Contract #: 04-0120F4Cty: SF/ALA Rte: 80 PM: 13.2/13.9File #: 69.28**WELDING INSPECTION REPORT****Resident Engineer:** Pursell, Gary**Address:** 333 Burma Road**City:** Oakland, CA 94607**Report No:** WIR-011816**Date Inspected:** 04-Feb-2010**Project Name:** SAS Superstructure**OSM Arrival Time:** 700**Prime Contractor:** American Bridge/Fluor Enterprises, a JV**OSM Departure Time:** 1900**Contractor:** Zhenhua Port Machinery Company, Ltd (ZPMC), Changxing Island **Location:** Shanghai, China**CWI Name:** Li Yang**CWI Present:** Yes No**Inspected CWI report:** Yes No N/A**Rod Oven in Use:** Yes No N/A**Electrode to specification:** Yes No N/A**Weld Procedures Followed:** Yes No N/A**Qualified Welders:** Yes No N/A**Verified Joint Fit-up:** Yes No N/A**Approved Drawings:** Yes No N/A**Approved WPS:** Yes No N/A**Delayed / Cancelled:** Yes No N/A**Bridge No:** 34-0006**Component:** OBG Segment**Summary of Items Observed:**

OBG # TRIAL ASSEMBLY YARD (Lift 6)

OBG # TRIAL ASSEMBLY YARD (6AW)

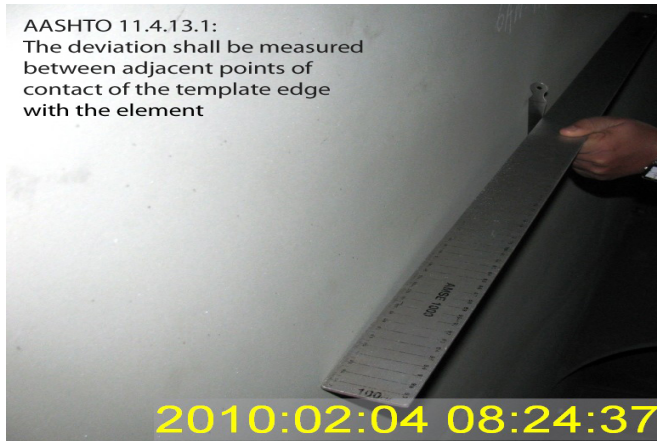
During the Quality Assurance (QA) random in-process visual inspection of OBG Lift 6 in the OBG Trial Assembly area, this QA inspector discovered the web plates exceeded the "flatness of panels" requirement at following panel points:

OBG Segment 6AW:

PP 38 Counterweight side.

-The FL1 floor beam FB11B

-6.5mm over 1000mm

PP 40 Crossbeam side.

-The FL3 floor beam FB33A

-14mm over 1000mm

- 8mm over 1000mm
- PP 43 Crossbeam side.
- The FL1 floor beam FB15A
- 7mm over 1000mm
- PP 43 Counterweight side.
- The FL1 floor beam FB9A
- 7mm over 1000mm at
- OBG Segment 6CW:
- PP 44 Crossbeam side.
- The FL3 floor beam FB35A
- 13mm over 1000mm
- PP 45 Crossbeam side.
- The FL3 floor beam FB31A
- 10mm over 1000mm
- PP 46 Crossbeam side.
- The FL3 floor beam FB27A
- 7mm over 1000mm
- All the measurements were taken below the upper flange plate.
- The maximum out of tolerance allowed per AASHTO 11.4.13.2 is 5mm.
